Access Compliance Report

Public Rights-of-Way

(Curb Ramps)

Intersection ID: 13769	Main Street: E_3RD_ST	Cross Street: CHERRY_ST	Location: SW
ADA ID: 22B3490C83C0	Ramp Type: PerpDiag	Initial Pass/Fail: Fail	Overall Compliance: No
		Severity Score: 12.5

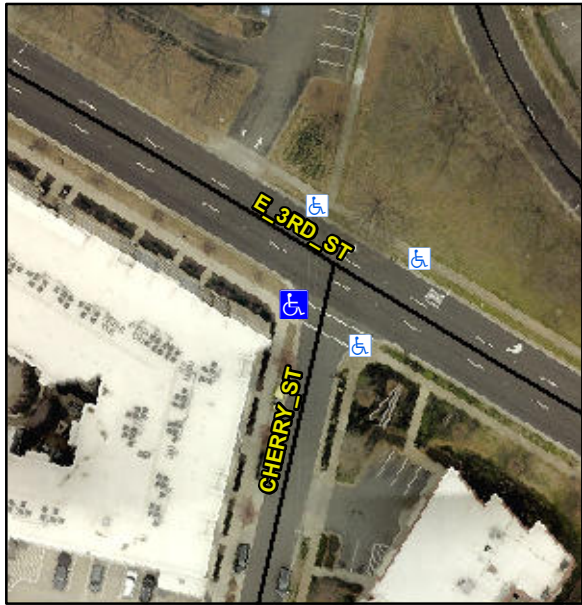
Codes/Mitigation Info/Possible Solution		Field Measurements/Component Compliance					
	Possible Solutions:						
	Remove & Replace Curb Ramp With Two New Directional Ramps or Equivalent.						
	Surveyor Notes:						
	N/A						
	PROW/ADA:						
	Not Found, R304.2.2						
		Compliance	Description	Data	Compliance	Description	Data
		Description	Data	Description	Data		
		N/A	Ramp Length (in)	80.0	No	Ramp Slope (%)	8.6
		Yes	Ramp Width (in)	48.0	Yes	Ramp XSlope (%)	0.2
	N/A	Flare Type LT	N/A	N/A	Flare Type RT	N/A	
	N/A	Flare Slope LT (%)	N/A	N/A	Flare Slope RT (%)	N/A	
	N/A	Flare Traversable LT?	N/A	N/A	Flare Traversable RT?	N/A	
	N/A	Landing Length (in)	N/A	N/A	DWS Provided?	N/A	
	N/A	Landing Width (in)	N/A	N/A	DWS Contrast?	N/A	
	N/A	Landing Slope (%)	N/A	N/A	DWS Length (in)	N/A	
	N/A	Landing X Slope (%)	N/A	N/A	DWS Full Width?	N/A	
	N/A	Landing Curb? (Y/N)	N/A	N/A	DWS Offset (in)	N/A	
	N/A	Shared Landing?	N/A
